JICA Experts on Bengaluru Peripheral Ring Road Project

SUBJECT: Submission of Record of Discussion on 11 May

Number	RD-PRR-DP-005
Objection	Technical Discussion based on Discussion Paper No. R02 & R03
Date	11 th May 2015 15:00~20:30
Venue	Meeting Room in DULT
Attendance	DULT : Mr. Shamanth K, Mr. Sivasubramaniam J BDA : Mr. Srinivask, Mr. H.C Ramendra, Mr. B Nagendra , Mr. Ajithkumar S.M STUP : Mr. T.V.Rajeev , Mr. Srivathsa B K JICA Experts: Mr. T. Tanaka, Mr. N. Kondo, Mr. S. Yamada
Handout	-Discussion Paper R02 (Road : Cross Sections, Vertical Alignment) -Discussion Paper R03 (Road : Junction/Toll Plaza/Rest Area)
Contents	<p>“Overall regarding Land Acquisition”</p> <p>Horizontal alignment will be reviewed based on the technical review by JICA Experts on DP R01 which technically required for fulfilling the design speed of 80km/h to accommodate within available ROW of BPRR. Final Decision will be taken by BDA after the revision in the detailed design. (It has to be confirmed by engineer member)</p> <p>“DISCUSSION PAPER R02 (Road: Cross Sections, Vertical Alignment)”</p> <p>1. Cross Sections</p> <p>1.1 General regarding Cross Sections</p> <p>Typical cross sections were updated i

Figure 1.2 Old Cross Section in Draft DPR

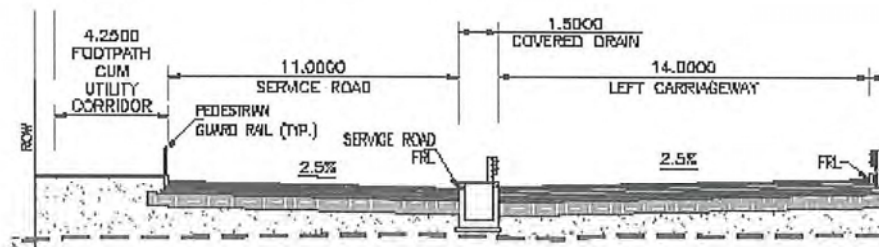
Cross sections on the junction drawings have not been updated. Old sections (without shoulders) are still used in these drawings.

However JICA Experts found the old cross sections (without shoulders) in the drawings of interchanges and junctions.

Agreed cross sections shall be used properly in the detailed design.

JICA Experts would like to request BDA and STUP to conduct the detailed design using only the agreed cross sections.

Figure 1.3 Proposed Concept of Partial Outer Shoulder for BPRR

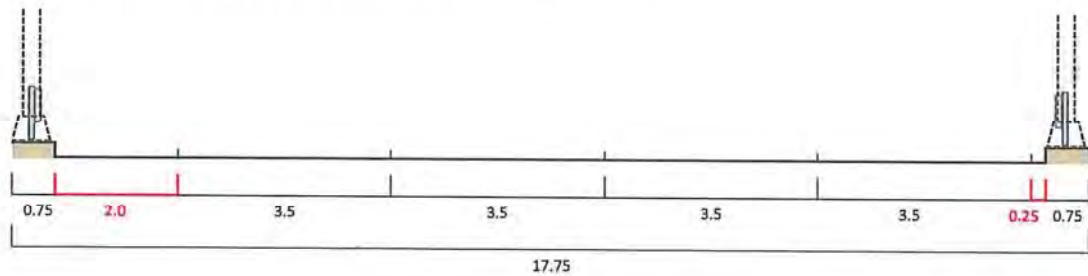
Comments on DPR: Width of the inner shoulder (edge strip) is too narrow for high speed traffic.
Suggestion from JICA Experts: Provision of 1.5m width for “Outer Shoulder” and 0.75m width for “Edge Strip/Inner Shoulder”

The width of edge strip in Final DPR of BPRR is 0.25m only and not fulfill the above requirement. Provision of 0.75m width of edge strip (inner shoulder) is recommended by JICA Experts.

The concept of the proposal of JICA Experts is shown in Figure 1.3. JICA Experts propose 1.5m width of the partial outer shoulder.

Figure 1.6 Cross Section of Service Road in Final DPR

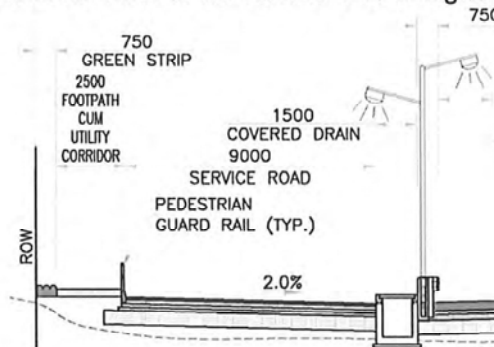
<p>Comments on DPR:</p> <p>Number of lanes for service road is not clearly mentioned in DPR.</p>
<p>Suggestion from JICA Experts:</p> <p>Each direction of the service road can accommodate 2-lane with "partial shoulder" and "edge strip."</p>

According to IRC-86, 3-lane roads require 10.5m of the carriageway width. Therefore 9.0m of the carriageway width for BPRR can accommodate only 2-lane.

Figure 1.7 Cross Sections of Mainline of BPRR (Draft DPR)

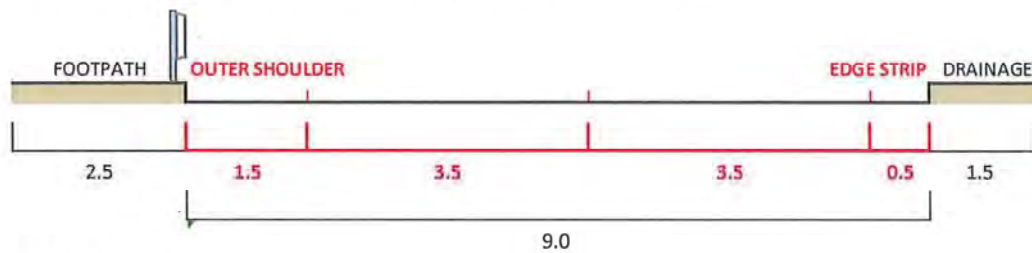
Figure 1.7 shows the cross section of the service road designed in DPR. Lane configuration of the service road is not shown on the drawing.

JICA Experts propose the lane configuration as shown in Figure 1.8.

Figure 1.9 Bottleneck of Carriageway

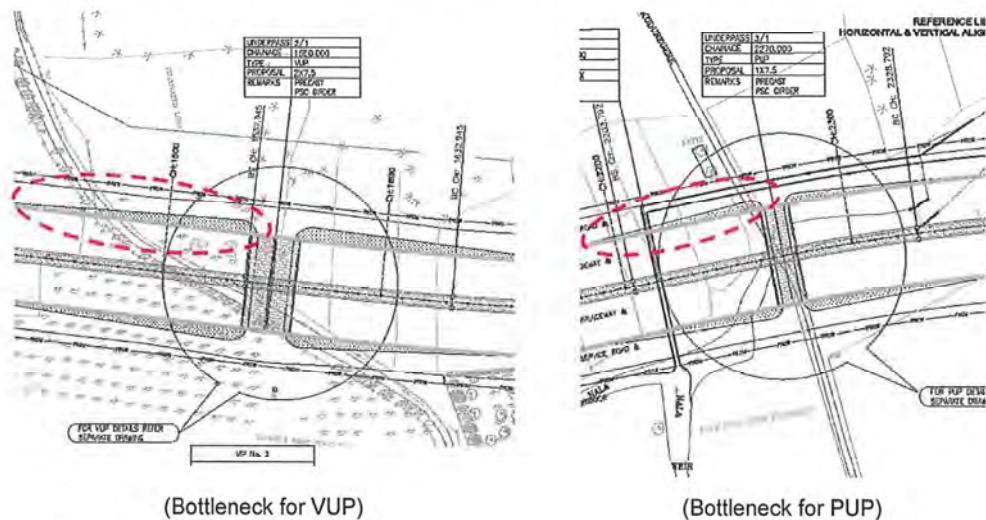
<p>Comments on DPR:</p> <p>Width of carriageway of the service road is narrowed at the approach to VUP and PUP.</p>
<p>Suggestion from JICA Experts:</p> <p>Flyovers or bridges shall be studied instead of box-culverts.</p>

The narrowed carriageway will induce traffic congestion and the width of the carriageway shall keep the original width (9.0m).

In DPR, the width of service roads is getting narrower toward the entry/exit of VUP and PUP as pointed out in the Discussion Paper. It was confirmed by STUP that compliance is already given to JICA 3rd Mission comments that the end of underpass will be flared (6m x 6m at VUP and 3m x 3m at PUP) in the detailed design stage to get sight distance and also to avoid narrowing of road section at approaches. Planning appropriate structure considering the turning radius of large-sized vehicles will be incorporated in the detailed design.

Figure 1.10 Vehicle Motion Path at VUP

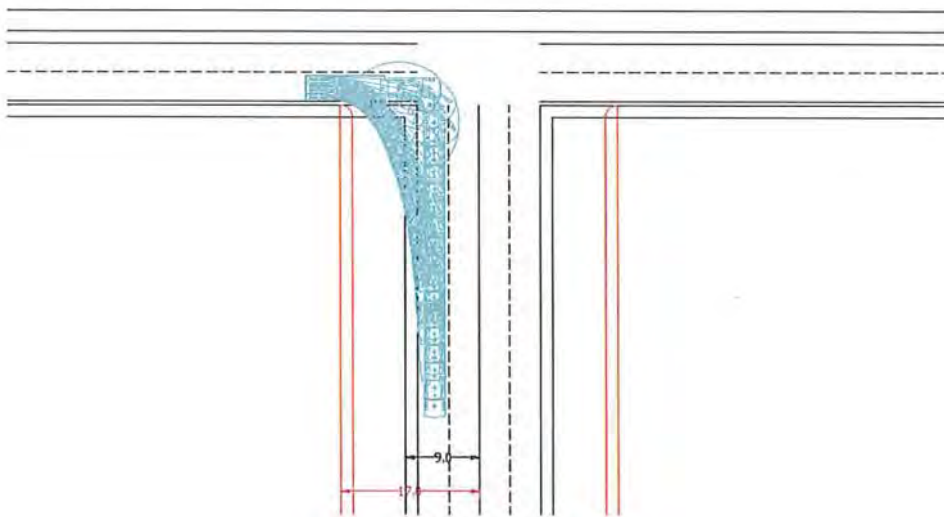
The proposed width of box-culvert cannot manage the traffic flow properly. In order to secure the minimum turning movement of these vehicle, width of the box culvert shall be much larger as suggested in Figure 1.10.

It is quite essential to consider heavy vehicle’s turning movement into the design of the VUP.

According to the result of the motion path presented in above figure, size of box-culvert shall be changed to much larger one. JICA Experts recommend flyovers or bridges instead of box culvert for VUP.

Figure 2.1 Insufficient Lateral Clearance for VUP/POP

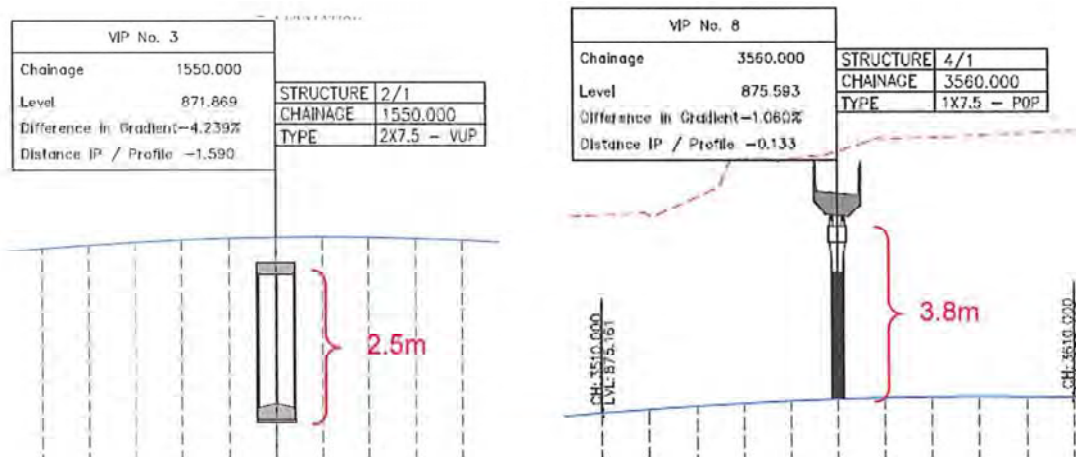
<p>Comments on DPR:</p> <p>Vertical clearance of 5.5m for vehicular underpasses, 4.5m for pedestrian underpasses</p>
<p>Suggestion from JICA Experts:</p> <p>Vertical clearance of 5.5m for vehicular underpasses, 4.5m for pedestrian underpasses</p>

JICA Experts reviewed the drawings based on above standard. JICA Experts have pointed out there are many sections do not fulfill the requirement for clearance as presented in the Table 2.3

It was agreed to modify the drawings properly reflecting the required clearance height for the overpass locations.

Figure 1.12 Height of MSE Wall at Chennai Railway Line (KM43+100)

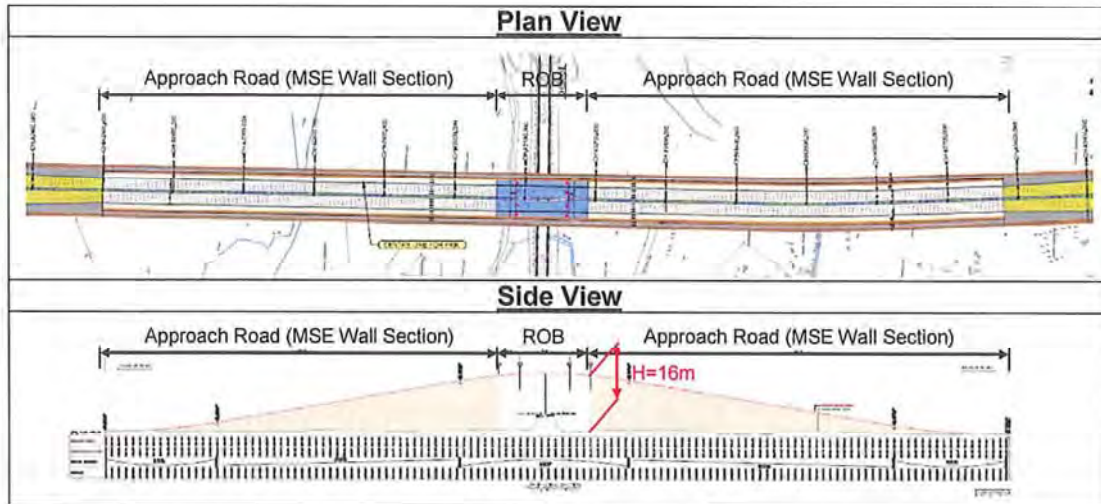
<p>Comments on DPR:</p> <p>Very tall MSE retaining wall is planned in DPR.</p>
<p>Suggestion from JICA Experts:</p> <p>It is better to set the limitation of the height of MSE. Otherwise, detailed analysis, such as FEM analysis, will be required for the tall wall.</p>

These exceed an experimental standard height (maximum 12m in general); therefore, structural measures or optional structure type are necessary to be considered.

JICA Experts recommend applying the standard height of MSE Wall by setting back the abutment locations (extending of ROB length) to assure structural aspects.

Figure 1.14 Draft Modifications for Vertical Alignment (2)

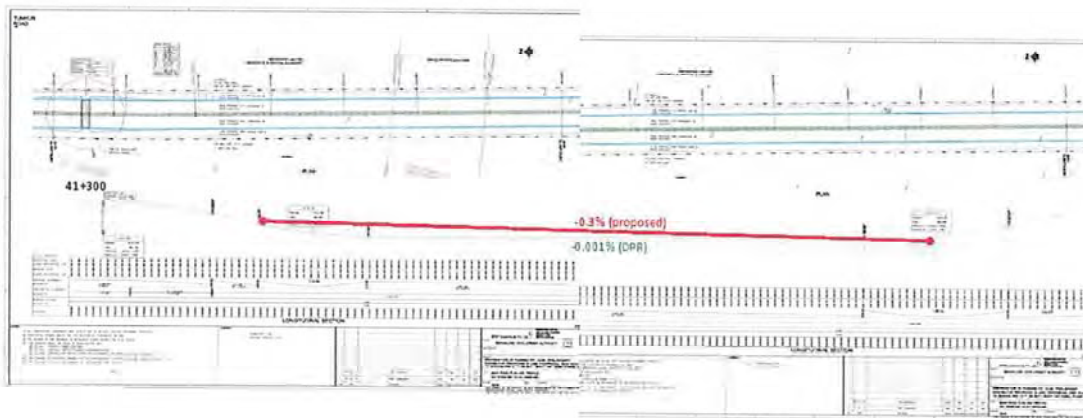
Some drawings do not fulfill the requirement for minimum gradient. JICA Experts shows example of modification as below.

Vertical alignment will be designed as mentioned in 2.1 above during the detailed design stage.

Figure 1.16 Draft Modifications for Vertical Alignment (4)

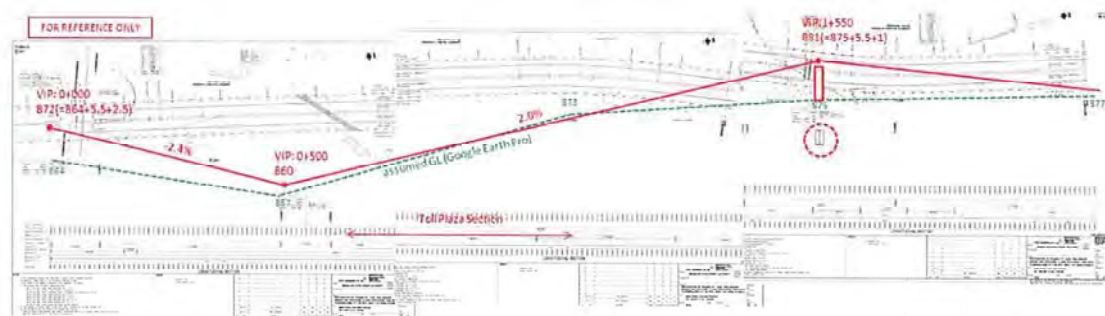
IPC-86 does not specify about the limitation of vertical gradient around toll plaza. Queuing vehicles toward toll booths are sometime stopping on the toll plaza. To avoid minor accident “face to rear hitting” by stopping vehicle due to unintended releasing of brake, the vertical gradient on the toll plaza shall be smaller. Japanese Toll Road Guideline (NEXCO) specifies 2.0% for desirable maximum gradient to avoid the incidents mentioned above.

It was agreed to apply 2.0% for the maximum vertical gradient for the toll plaza section.

JICA Experts propose minor modification of the vertical alignment of BPRR as introduced below.
